UNITED STATES
DEPARTMENT OF THE INTERIOR
BUREAU OF LAND MANAGEMENTFORM APPROVED
OMB NO. 1004-0137
Expires: January 31, 2018**SUNDRY NOTICES AND REPORTS**
*Do not use this form for proposals to drill or to re-enter an abandoned well. Use form 3160-3 (APD) for such proposals.*5. Lease Serial No.
NMNM0559539

☒ Oil Well ☐ Gas Well ☐ Other2. Name of Operator
CIMAREX ENERGY COMPANY OF COContact: TERRI STATHEM
E-Mail: tstatthem@cimarex.com3a. Address
202 S CHEYENNE AVE. SUITE 1000
TULSA, OK 741033b. Phone No. (include area code)
Ph: 432-620-19368. Well Name and No.
JAMES 19 FEDERAL 31H9. API Well No.
30-025-42222-00-X1

Cimarex Energy Co. respectfully request approval to change the original approved rig layout diagram. The rig layout including v-door and flare line may change depending on rig availability. The pad dimensions and orientation will remain the same. There will be no additional disturbance if a rig layout change is necessary to accommodate the drilling rig.

PECOS DISTRICT DRILLING CONDITIONS OF APPROVAL

Borehole: Original Borehole Well: Cimarex James 19 Federal 31H Field: NM Lea County (NAD 83) Structure: Cimarex James 19 Federal 31H

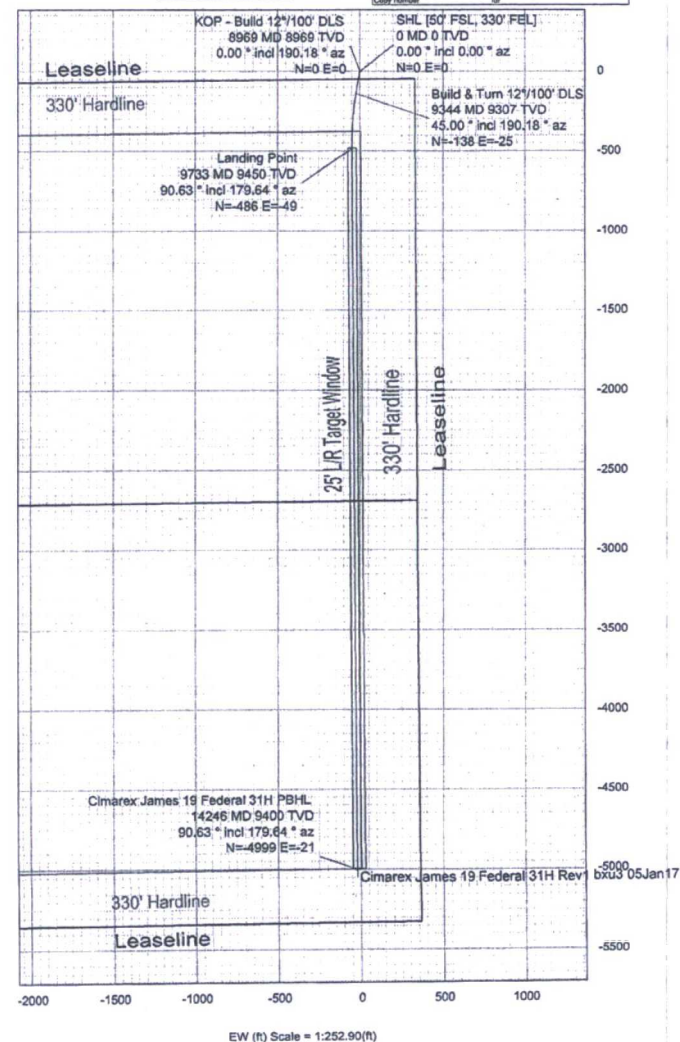
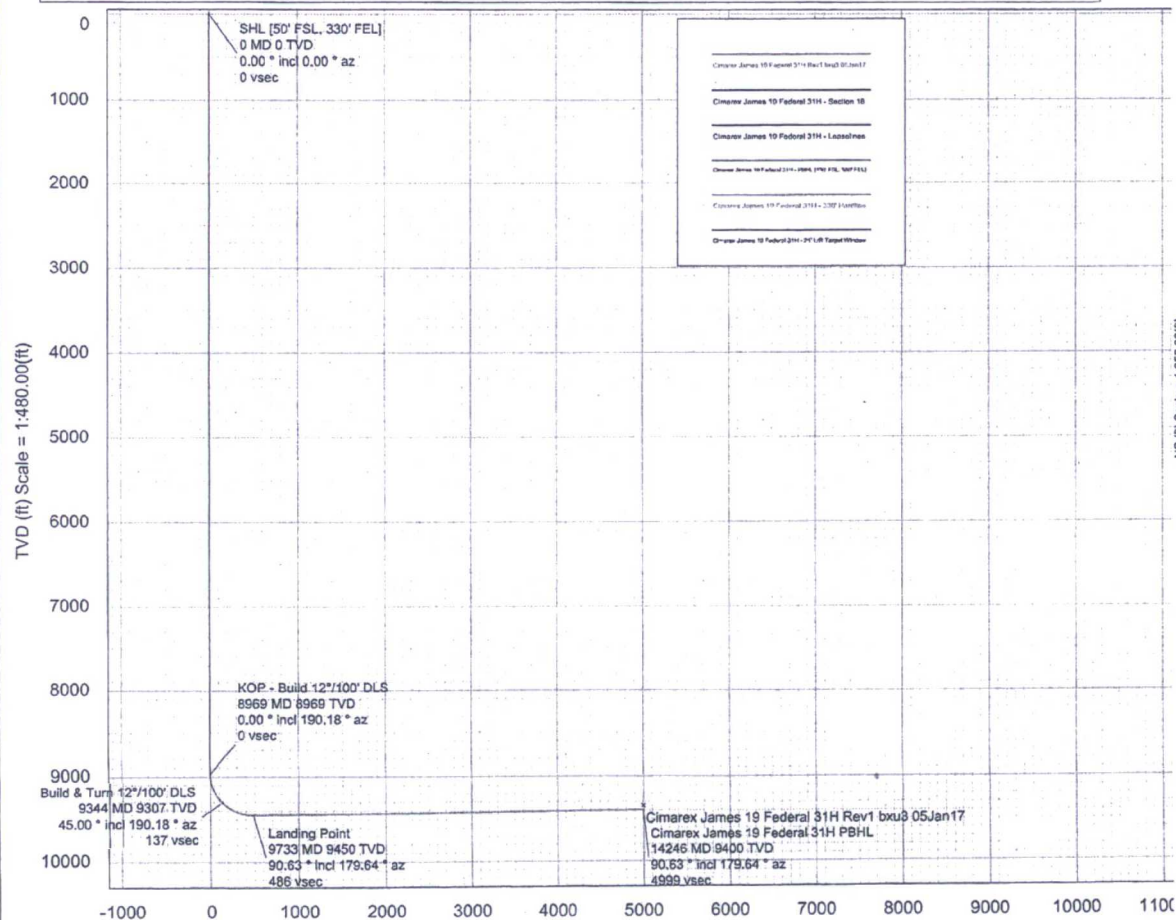
Please also see attached directional plan for the change from 440' FEL to 380' FEL targeting the avalon.

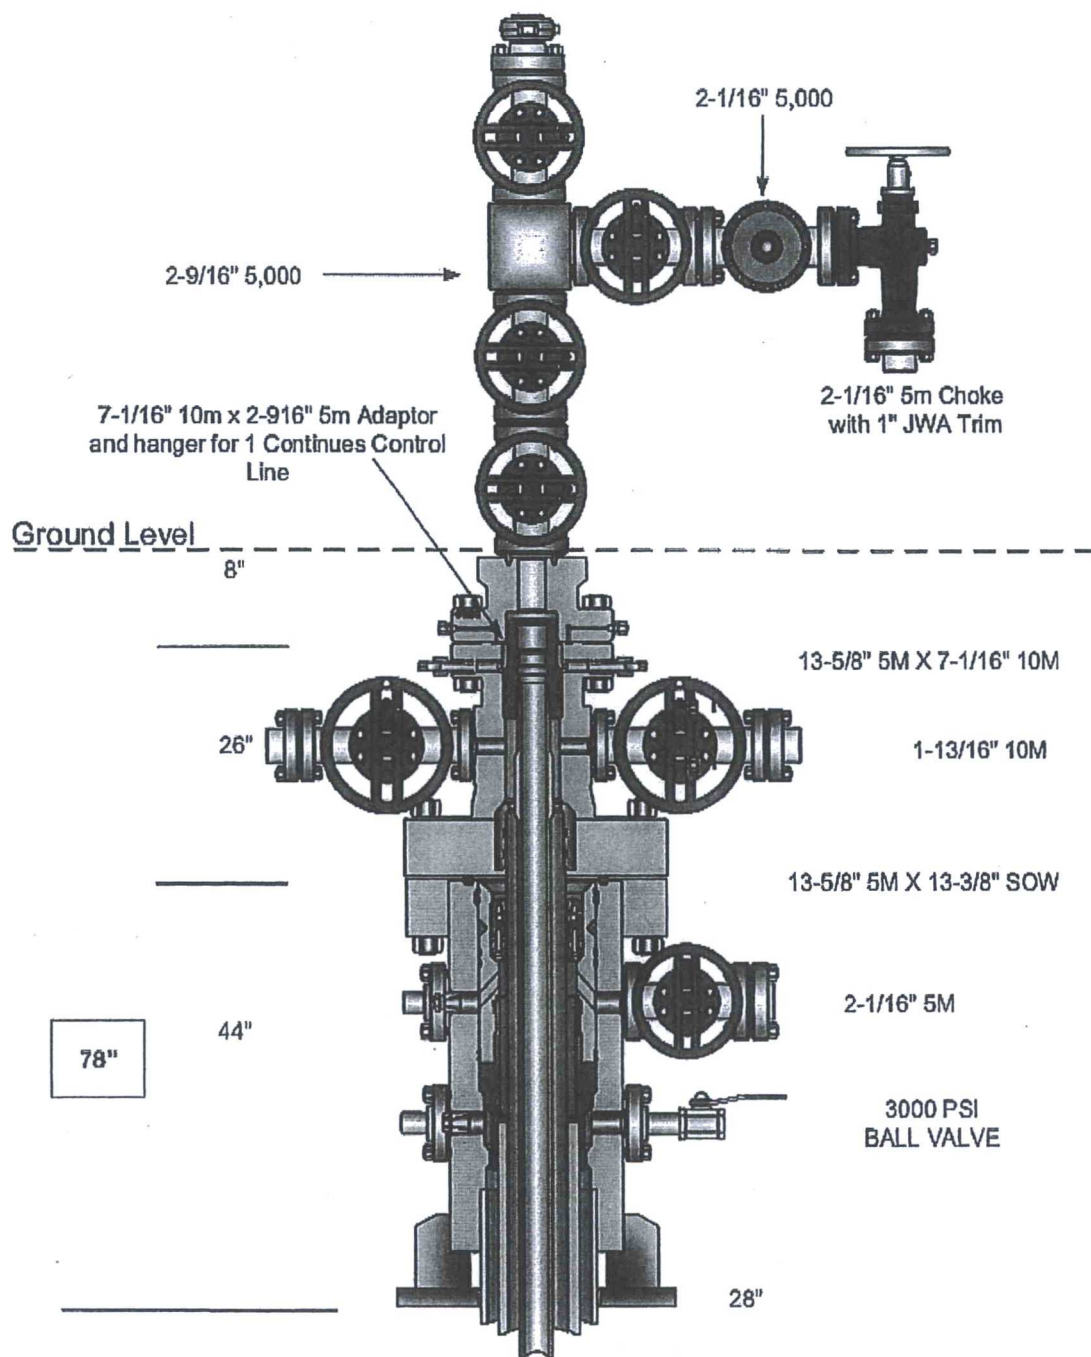
Cimarex respectfully request approval for a multibowl wellhead, please see attached diagram and procedure.

4. **If the operator has proposed a multi-bowl wellhead assembly in the APD. The following requirements must be met:**
 - a. **Wellhead shall be installed by manufacturer's representatives, submit documentation with subsequent sundry.**

- b. **If the welding is performed by a third party, the manufacturer's representative shall monitor the temperature to verify that it does not exceed the maximum temperature of the seal.**

- c. **Manufacturer representative shall install the test plug for the initial BOP test.**
 - d. **If the cement does not circulate and one inch operations would have been possible with a standard wellhead, the well head shall be cut off, cementing operations performed and another wellhead installed.**
